RESPONSE TO AEC QUESTIONS

SUBJECT: RGE - Pressurizer Safety Valve
Discharge Piping Time History
Dynamic Analysis

MAR 15 1973

FIG. 2
PCV 434

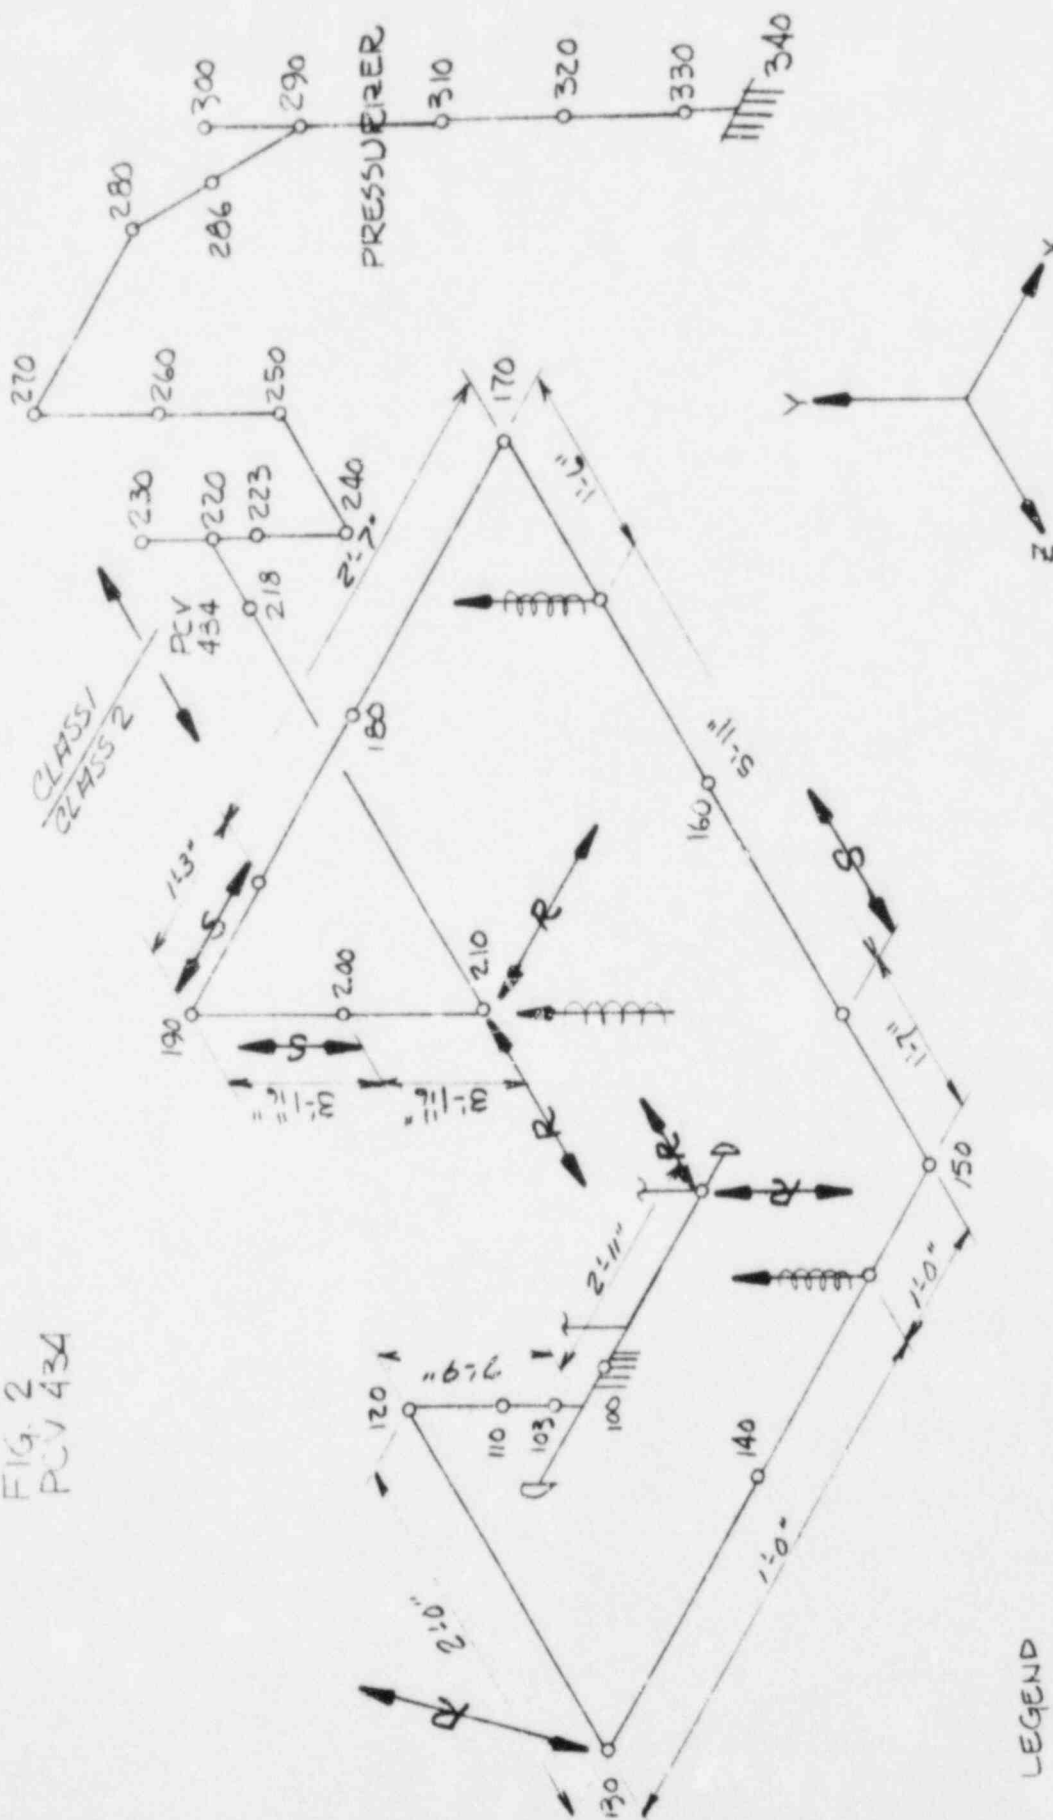
Question: How many degrees of freedom are considered in the analysis?

FIGURE 2 (PCV 434) shows the 22 lumped mass model. The system is analyzed for 22×3 66 degrees of freedom.

Answer: FIGURES 1 and 2 show the lumped mass mathematical model used in the time history analysis. Support and restraints are represented as springs in the model. The time history dynamic solution employs the following computer codes. A brief description of the function of each code is also provided.

Figure 3
PVC 435
Point 234

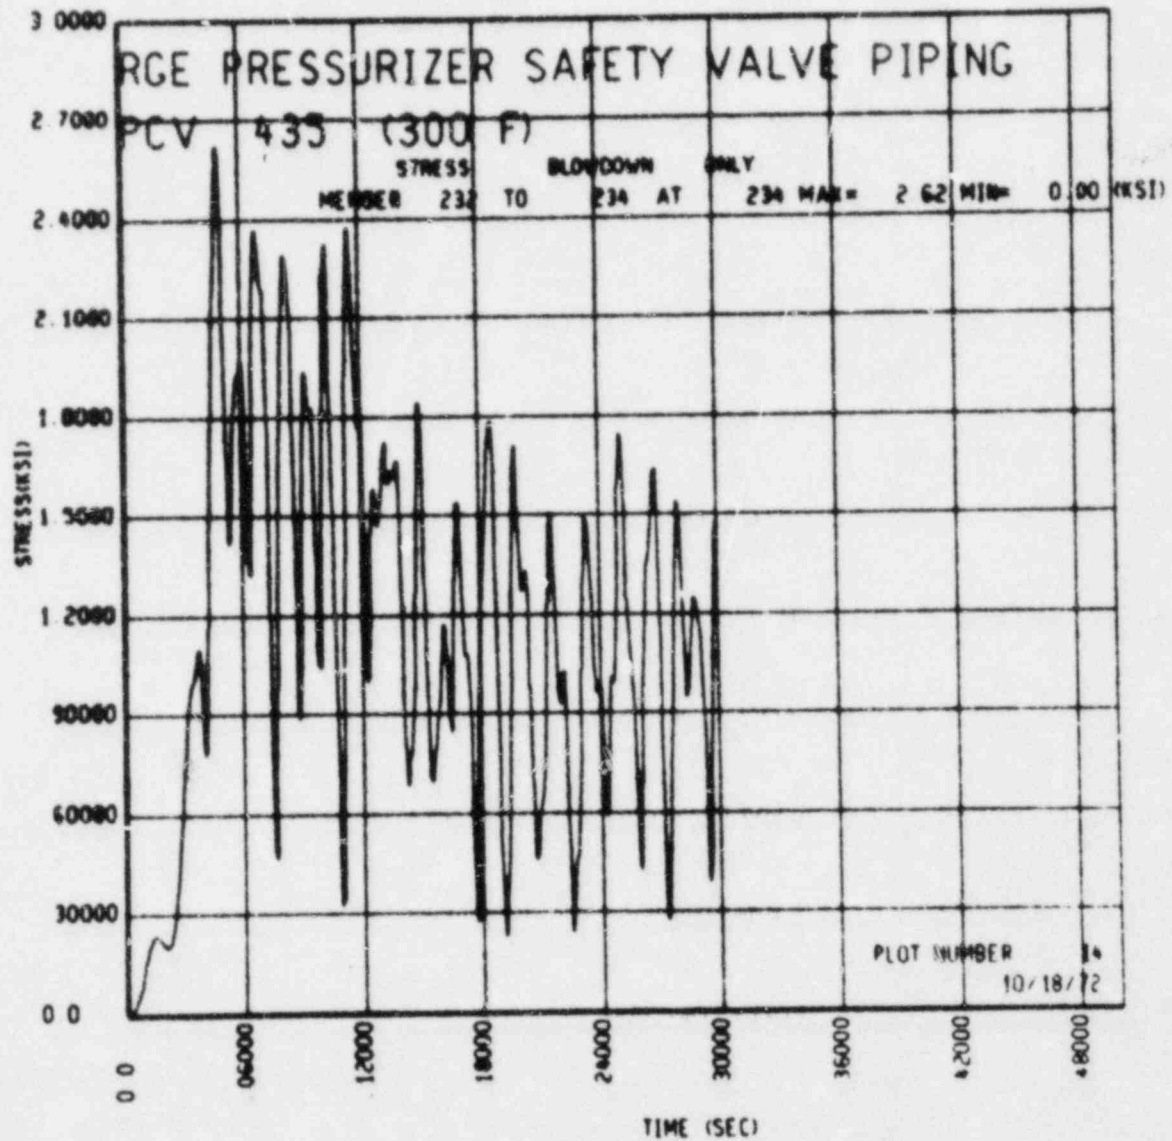
Question: Furnish the time history plots of the most highly stressed node point in each system.

Answer: The Figure 3 shows the maximum stress from the time history analysis for the PCV 435 (FIGURE 1).

Figure 5
PCV 435
Point 240

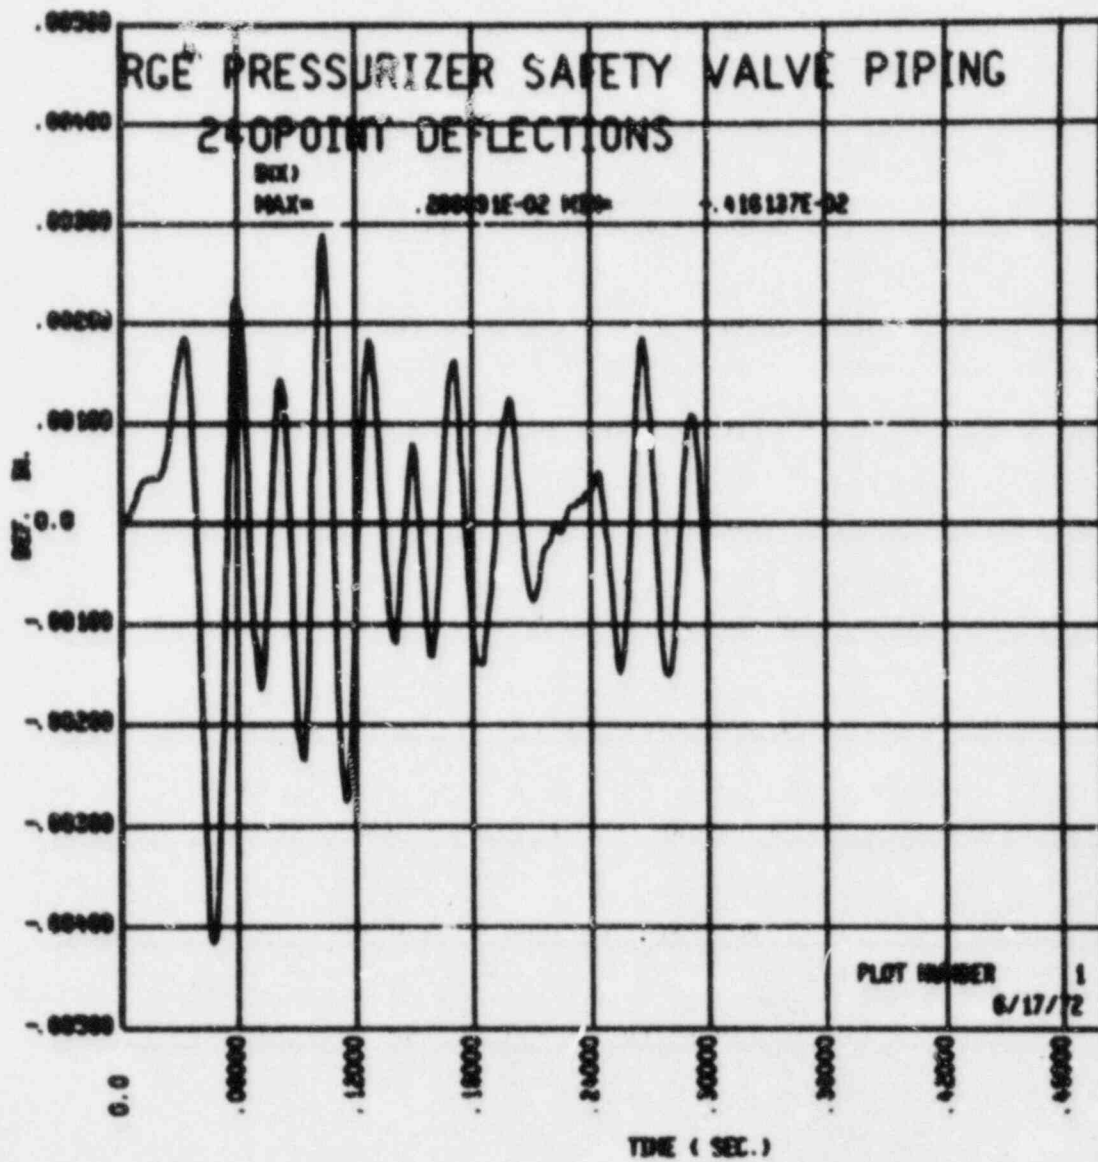
Question: Furnish the plots of the time history displacements for each line at or near the most highly stressed point.

Answer: The figures 5, 6, and 7 show the time history displacements in X, Y, and Z directions for line PCV 435 (FIGURE 1).
